**MANDATORY SERVICE BULLETIN No. Z 242/5**

1. Subject: All manufactured Z 242L airplanes including S/N 0659.
2. Reason: The correct function of the L242.1510-03.00 Bushing may be inadversely affected by the dimensional tolerances of parts.
3. Measures: In assemblies:  
L 242.7310 Central throttle control  
L 242.7500 Mixture control  
L 242.7700 Cooling flap control  
L 242.7800 Propeller control

Obr. 1

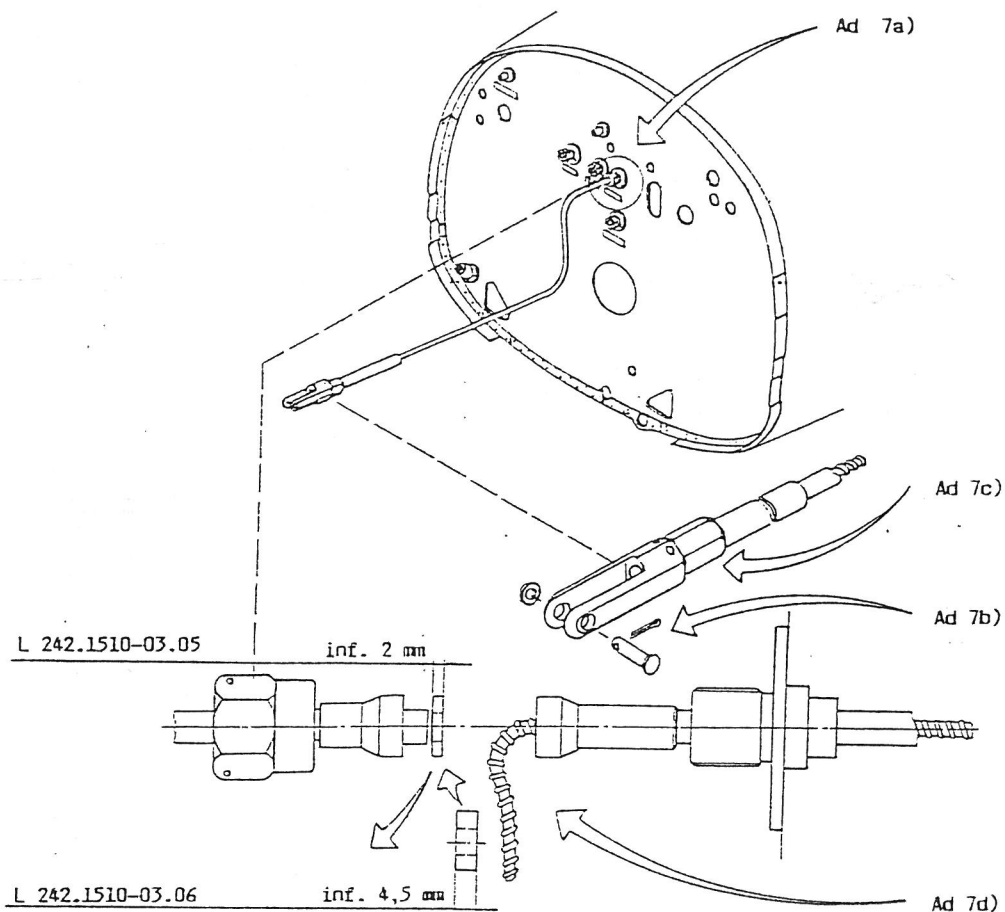
replace the L242.1510-03.05 Ring (2mm thick) by a modified L242.1510-03.06 one (4,5 mm thick) in critical Bushing L242.1510-03.00.
4. Carry-out till: Immediately after receipt of this Bulletin
5. Carried-out by: The User
6. Expenses covered by: The replacement and marking the User, material (new L242.1510-03.06 Rings 4,5 mm thick) is supplied by the Manufacturer.
7. Procedure: see Fig. 1.
  - a) disconnect the Bushing L242.1510-03.00, release the Cap-nut L242.1510-03.02.
  - b) disconnect the flexible rod fork from the appropriate lever on the engine by pulling-out the pin
  - c) release the joint between the Fork and the Guide, release the flexible rod cable
  - d) in assemblies: Central throttle control  
Mixture control  
Propeller control

Let the Cap-nut and 1 piece of bush on the flexible - rod tube, pull - out the cable from the front tube, take out the "old" L242.1510-03.05 (2mm) Ring, insert the "new" L242.1510-03.06 (4,5mm) one.

check marking red strip

Obr. 2

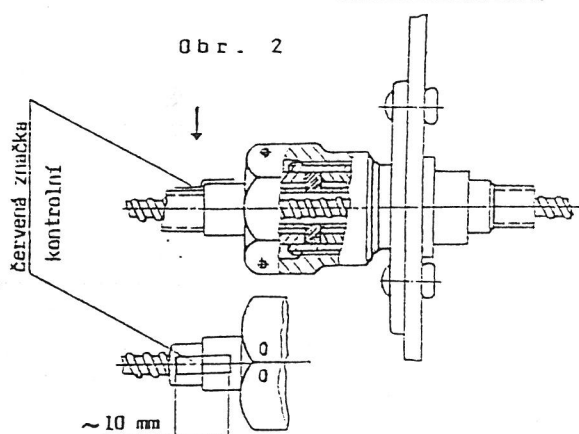
During reassembly check carefully that both flexible rod tubes (from the engine and pilot compartment parts) are fully pushed - in the bushes, seating fully on the Ring faces according to Fig.2!

In assemblies	Central throttle control
	Mixture Control
	Propeller Control
	according to Fig.2
In assembly	Cooling flap control
	acc. to Fig.3

Obr. 3

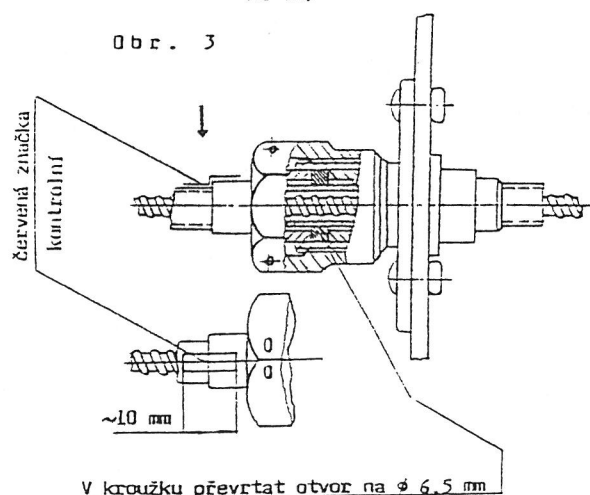
Release and take out from the front flexible rod tube towards the engine the Cap nut, 1 piece of Bush and the Ring 2 mm thick. Replace this Ring by the new L242.1510-03.06 one 4,5 mm thick, after redrilling it's inner diameter on 6,5 mm. Slide the parts back on the rod tube.

redrill the ring on 6,5mm  
inner dia in this case
